UNITED STATES
NUCLEAR REGULATORY COMMISSION
OFFICE OF INSPECTION AND ENFORCEMENT
WASHINGTON, D.C. 20555

IE Bulletin No. 80-20

FAILURES OF WESTINGHOUSE TYPE W-2 SPRING RETURN TO NEUTRAL CONTROL SWITCHES

FIGURE 1

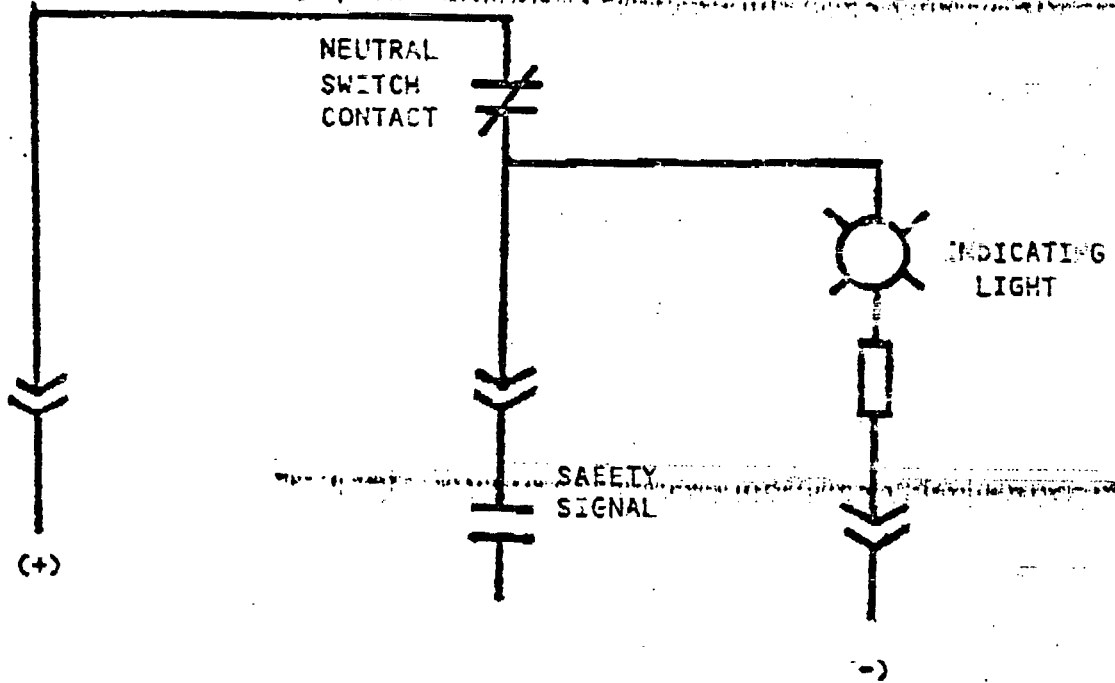
A review of this matter by Westinghouse led to the issuance of NSD Technical Bulletin No. NSD-TB-80-9 to the utility owners of all Westinghouse operating plants. The recommendations contained in the Westinghouse technical bulletin include: (i) testing the neutral position contacts of the subject W-2 switches for continuity, and (ii) rewiring of the indicating light circuit to permit the early detection of a neutral contact failure as shown in Figure 1.

Depending on how the indicating light circuit is wired, loss of continuity thru the neutral position contact of a W-2 switch could remain undetected until the equipment associated with the switch were called upon to operate. Since such a failure would be equivalent to by-passing the system associated with the switch, consideration should be given to rewiring the switches used in safety-related applications as shown in Figure 1. Such rewiring would provide an acceptable means for detecting contact failure, provided the indicating light is in the control room and readily visible by the operator. If the indicating light is not so located, consideration should be given to annunciating the neutral position contact failures at the control room to alert the operator of the inoperable status of a safety-related system. In addition, consideration should be given to adding redundant contacts to the W-2 switches or to replacing the W-2 switches with others having a more positive contact wiping action.

3. Licensees of operating plants and holders of construction permits shall describe the longer term corrective measures planned and the date by which such measures will be implemented by actual installation or by design change, as appropriate. As a minimum, the longer term corrective measures should include rewiring the indicating light as shown in Figure 1 provided the light is readily visible to the control room operator. If not, failures of the neutral position contacts should be annunciated in the control room.

REWIRING OF INDICATING LIGHT CIRCUIT OF W-2 SWITCHES
AS RECOMMENDED BY WESTINGHOUSE TECHNICAL BULLETIN WSD-TB-80-9
